Plumbing and wet-room study · round 1 · inventory, overlay, constraints, scores, alternatives, three scenarios, the utility room · Taif / Palm House V8.1 · STUDY ONLY

Design review E-03, G-07 · open item 10 · 2 Nov 2026 · the latest geometry (the flipped stair, the family bath F-b, the south wing v2, the maid room and kitchen changes, the site plan's manholes and septic route) · **every size is assumed, to be designed by the plumbing engineer** · nothing in the design files changes until the owner decides

OVERLAY · the first-floor wet rooms (green = over a wet / service room, red = over the kitchen) on the ground floor · dots: wet points (blue GF, brown FF) · 1 m = 0.56 cm

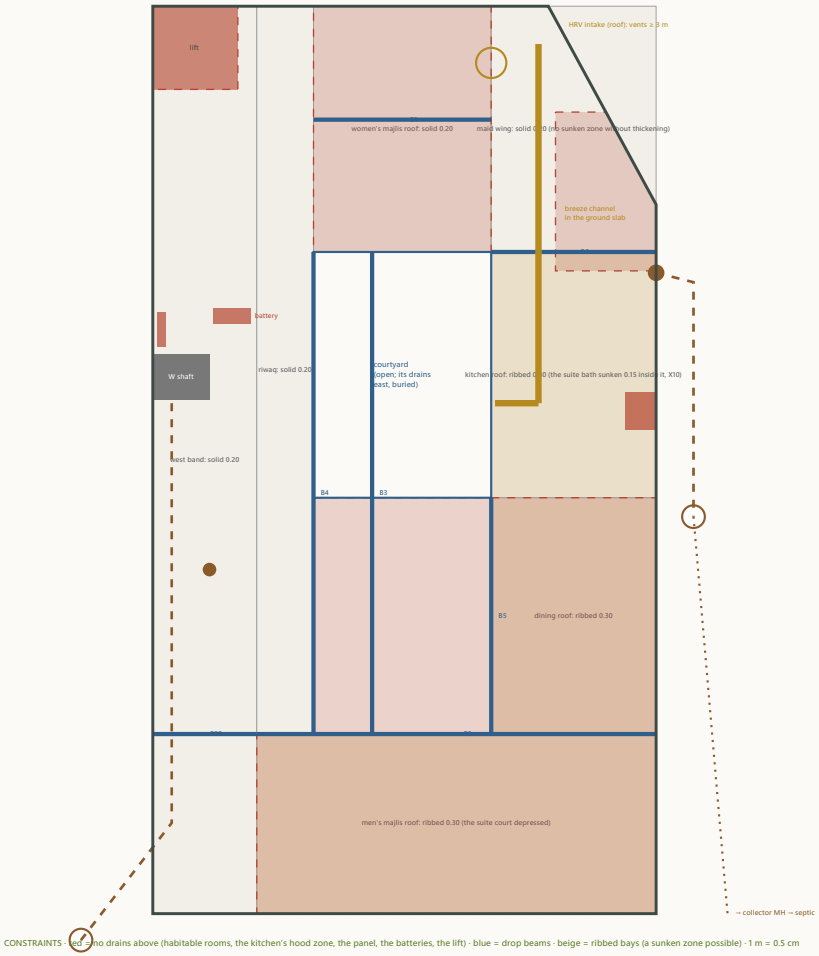
First-floor wet room	Below it	Verdict
Bedroom 2 bath	Utility room (shaft), Hospitality kitchen, Lobby + riwaq	good: over wet / service
Family WC	Utility room (shaft), Lobby + riwaq	good: over wet / service
Bedroom 3 bath	Family powder room	good: over wet / service
Suite bath	Maid room (a bedroom), Laundry, Kitchen	problem: over the kitchen
Suite WC closet	Maid room (a bedroom), Kitchen	problem: over the kitchen

CONSTRAINTS · red = no drains above (habitable rooms, the kitchen's hood zone, the panel, the batteries, the lift) · blue = drop beams · beige = ribbed bays (a sunken zone possible) · 1 m = 0.5 cm

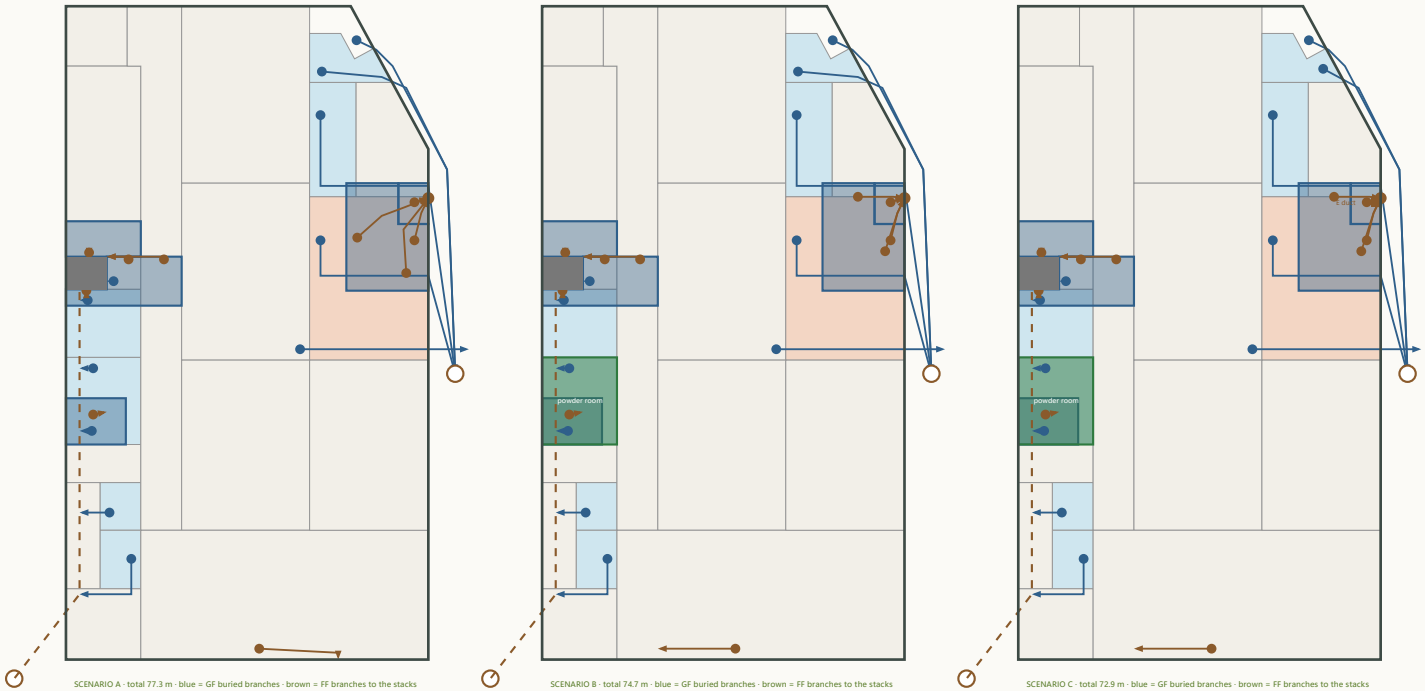
No-drain zones above

- **Habitable rooms (no drains in their ceilings):** the women's majlis, the men's majlis, the living and the dining, the maid room (a bedroom); on the first floor every bedroom, the kids' room, the family living, the office and the gym carry only the roof (no first-floor fixtures above them). **The kitchen:** its **hood zone** on the east wall (y 10.2–11.2) takes no drain above it; the rest of the kitchen's ceiling carries the suite bath only inside a sunken tanked slab (no suspended pipes in the kitchen's ceiling). **The electrical panel and the battery space** (the utility room's north part) and the **lift shaft**: nothing above or beside.

- **Drop beams** (blue): B1 (y 3.0), B4 (x 4.25), B5 (x 8.95 south of y 13), B6 (y 6.5), B8 / B22 (y 19.25), the edge beam B3: a drain never crosses a drop beam; branches run parallel to them or through sleeves cast in the hidden beams (the engineer).

- **Slabs:** the west band, the riwaq, the maid wing and the women's majlis roof are **solid 0.20**: a sunken bathroom zone there means a thicker bay (0.35 with the top depressed 0.15) or a raised floor; the kitchen, dining and men's majlis roofs are **ribbed 0.30**: a 0.10–0.15 depressed zone is possible (the suite bath has one). The family bath F-b over the utility room / hospitality kitchen is on the solid west band: its sunken zone needs the thicker bay (X10-type detail) or its drains stay suspended above the two **service** rooms behind panels (allowed by principle 4).

- **The malqaf breeze channel** (amber) in the ground slab from the tower south on x 10.2 to y 10.5 then west under the kitchen's sink counter: the kitchen's drain crosses it (the sink's branch passes **under** the channel's base slab, or the channel bridges it: the engineers); the **foundations** (pads ≈ 1.5 × 1.5 under the columns, strip footings under the RC walls): the buried drains pass between them; the **courtyard**: its drains run east under the kitchen floor to the east manhole's rain branch.

A1 · The suite bathroom over the kitchen · enlarged plans: (a) every drain in the sunken tanked slab (current) · (b) the east service wall + the tub’s plinth

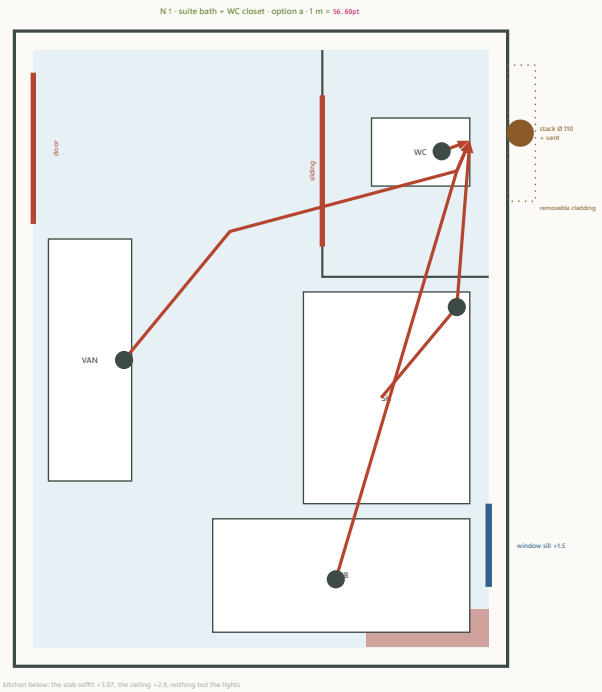
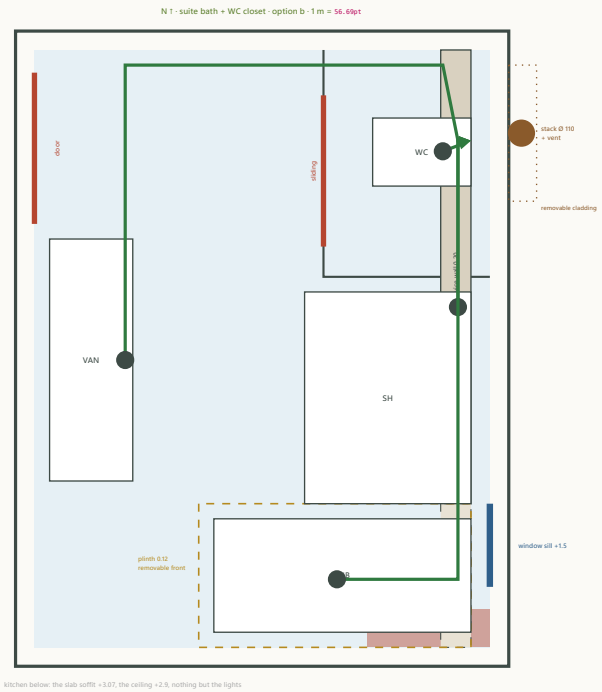
- The bath x 10.3–13.311, y 6.5–10.45 (3.01 × 3.95 on axes) with the WC closet in its north-east part (12.211–13.311 × 6.5–8.0, sliding door); the **stack outside the east wall** at y 7.05 behind a removable cladding panel, its branch fittings at the first-floor level, its vent to the roof; the **east window** y 9.5–10.05 (sill +1.5); the **hood zone** of the kitchen below starts at y 10.2 on the east wall: the depressed slab reaches y 10.45 but **no drain runs south of y 10.15** (the tub’s outlet at y 10 checked).
- **Fixtures** (`studies/ff_suite.typ`): the WC in the closet on the east wall (its outlet 0.2 m from the wall), the walk-in shower on the east wall y 8.1–9.5, the freestanding tub on the south wall by the window (its waste at x 12.3), the double vanity on the west wall (its trap 2.9 m from the stack by the floor route).

(a) all in the sunken tanked slab (current, red)

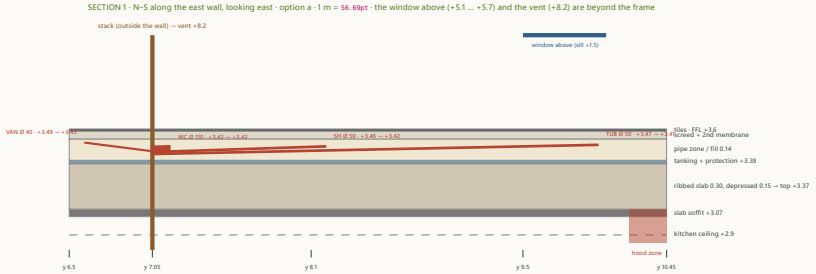
- The ribbed slab’s top is depressed 0.15 over the whole bath (+3.37); the build-up from it: the tanking membrane and its protection screed (+3.39), the **pipe zone 0.14 m**, a lightweight fill, the 50 mm screed, the second membrane under the tiles, the tiles (+3.6). The four drains lie in the fill at 2 % to the east wall and pass through it into the stack’s branches: all four fit (page 8), the WC’s Ø 110 with 0.02 m and the tub’s flat trap on its diagonal with 0.02 m to spare at the stack: tight.
- **Buried:** the WC’s bend, the shower’s gully and its outlet, the tub’s trap and its 3.1 m outlet, the vanity’s 3 m outlet and every joint of them. Reached only by lifting tiles, screed and the second membrane; the tanking under them stays.

- **(a):** the pipe zone is 0.14 m; the WC's Ø 110 (an S-trap pan, its bend 0.07 under the tiles) fits with 0.02 m to spare over its 0.19 m run; the shower gully (0.09 body) and the vanity (0.07 bend) fit with 0.03 and 0.04 m to spare; **the tub fits only with a flat 0.08 trap on the straight diagonal under the shower** (0.02 m to spare): at the limit of the build-up, with a 0.10 trap or a run along the walls it does not fit at 2 %. Nothing hangs under the slab: **the kitchen ceiling carries only the lights** (the soffit +3.07 under the depressed zone, the gypsum at +2.9): also in (a). But every drain and joint is under 0.07 m of screed, membrane and tile.

(b) the east service wall + the tub’s plinth (green)

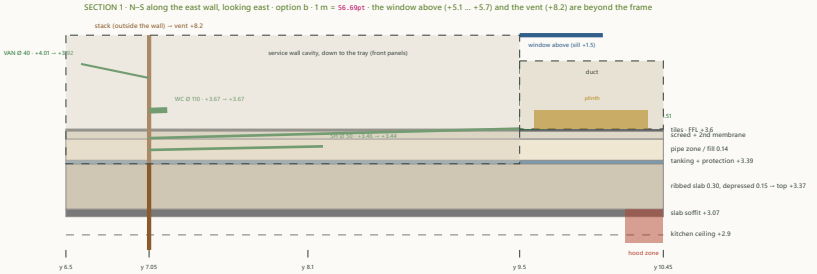
- A **0.20 m service wall** inside the east wall from the closet to the shower’s end (y 6.5–9.5, full height, its cavity down to the depressed slab), continued as a **0.45 m high duct** under the window to the south wall; the **WC wall-hung** on the wall’s frame with its outlet **horizontal at +0.18 straight through the wall into the stack** (0 m of floor pipe); the **shower channel along the service wall with its trap body inside the wall cavity**; the **tub on a 0.12 m plinth with a removable front** (its trap in the plinth’s void above the floor; the pipe in the plinth, the duct and the wall to the stack, 3.79 m at 2 %, arriving at +3.51, at about the floor level inside the wall cavity, 0.14 m above the tray); the **vanity’s Ø 40 in a chase in the north wall at +0.45** (one jointless pipe from its bottle trap) into the service wall. **What still lies in the floor:** the shower channel’s body only (set in the screed at the wall, its trap in the wall). Note: the door on the west wall (y 6.65–7.65) is not touched; the chase runs behind the plaster above the skirting.

- **(b):** no pipe below the tiles except the channel's body (0.10 deep in the screed, at the wall); the WC's outlet at +0.18, the channel's trap at +3.51 in the cavity, the tub's pipe from +3.62 to +3.51, the vanity's chase from +0.45 to +3.92: all above the tray, reached from the room side.

- **(b)**: the east service wall with the wall-hung WC, the wall-drain shower channel and the tub's plinth; the vanity's jointless chase. Every drain, trap and joint but one is reached from the room side or from the stack's cladding outside without cutting a finish; **the one exception is the shower channel's body** (its insert, strainer and seal come out from the front; the body itself, if it ever fails, needs a local opening ≈ 1.4 × 0.3 m of tiles and screed along the wall and the membrane re-made there, the tray below untouched). That is the smallest opening in the room and the best practical compromise: a channel body is a passive part with no moving element.

(c) a raised floor with removable panels

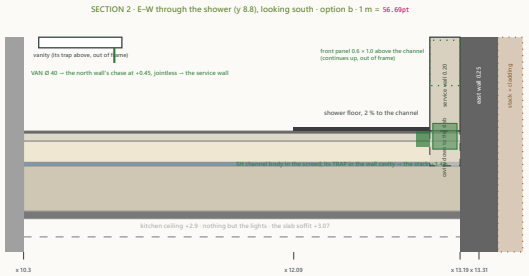
- A floor on pedestals over the tanked slab with lift-out tiles is practical only where no water falls on it: it cannot be sealed and removable at once in the shower. It works for the **tub’s zone** (= the plinth of (b)) and for a **dry strip along the west wall** under the vanity (0.6 wide, lift-out stone slabs over the vanity’s pipe): used in (b) as the plinth; the west strip is an option if the owner prefers the vanity’s pipe in the floor to a wall chase.
